Car Stereo  
Service Bulletin

**Model:** CDX-44/6020/7540/7580/R77/R79

**No.** 174

**Subject:** Some Functions Do Not Operate

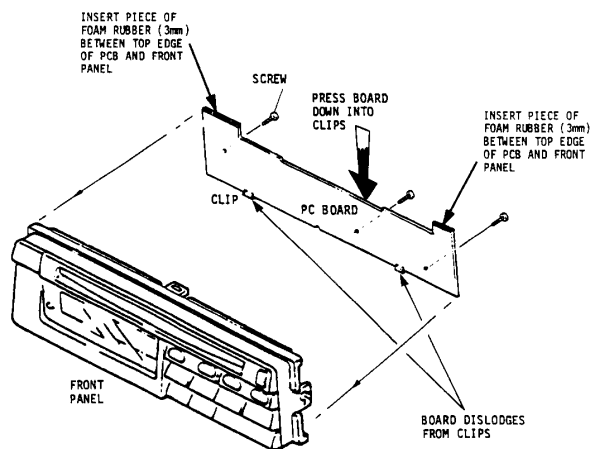
**Symptom:**  
(22)

The Display PCB becomes unseated from the plastic clips that hold the lower edge of the board causing no operation of several buttons on the front panel.

**Solution:** If this symptom occurs, insert a 3mm piece of rubber foam, Part Number 9-911-815-01, between the Front Panel and the top edge of the PCB, as shown below.

When installing the unit, press the PCB following the arrow and tighten screws.
